BVY 13-023

SUBJECT: License Amendment Request; Changes to 10 CFR 50.63 Licensing Basis, Supplement 2
Vermont Yankee Nuclear Power Station
Docket No. 50-271
License No. DPR-28

Response to Request for Additional Information

REQUEST FOR ADDITIONAL INFORMATION
REGARDING LICENSE AMENDMENT REQUEST TO CHANGE
THE LICENSING BASIS FOR SATISFYING 10 CFR 50.63
ENTERGY NUCLEAR OPERATIONS, INC.
VERMONT YANKEE NUCLEAR POWER STATION
DOCKET NO. 50-271
LICENSE NO. DPR-28

Figure 1 - Temporary Fuel Oil Fill Connection

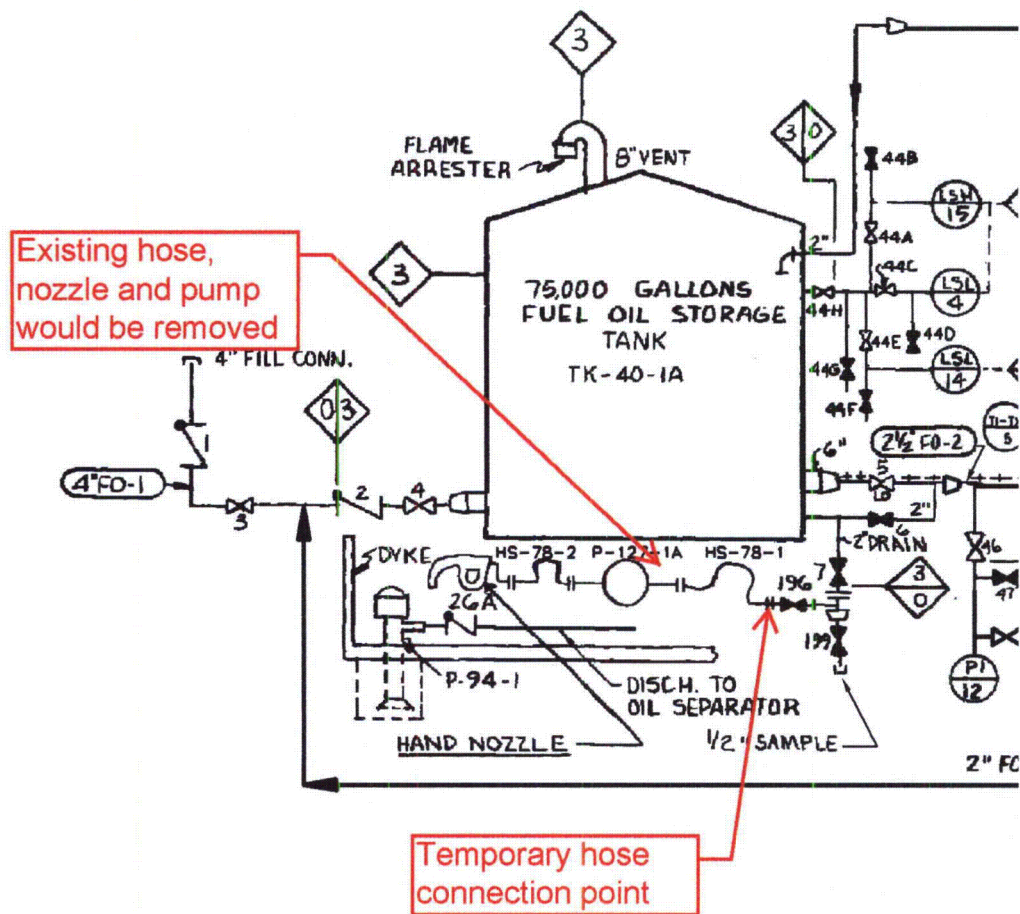
If a portable tank is used, describe how fuel oil is transferred from the emergency diesel generator (EDG) fuel oil storage tank to the portable tank and from the portable tank to the SBO DG fuel oil storage tank. If pumps are required, describe how they are powered. If a temporary connection between the storage tanks is used, provide a piping schematic showing where the connection is located in the existing fuel oil piping.

As documented in our license amendment request, the SBO DG will include a dedicated fuel oil storage tank with a capacity sufficient for operation of the DG at 100% rated load for at least 36 hours, which provides significant margin over the 8 hours of operation required by the coping analysis. This dedicated fuel oil storage tank will be separate from the fuel oil supply for the onsite emergency AC power system. As referred to in this question one possible means to refill the SBO diesel tank will be from the onsite EDG fuel oil storage tank using a portable tank or a temporary connection between these tanks.

Pump power can be supplied from new Bus 13 via the load center located in the SBO DG enclosure. Bus 13 is powered by the SBO DG; therefore, any electric-driven pump needed will remain powered during an SBO event. Other means may be possible including vendor-supplied deliveries, manual pumps or other vehicle battery powered pumps.

A piping schematic showing where the connection is located in the existing fuel oil piping is shown in Figure 1.
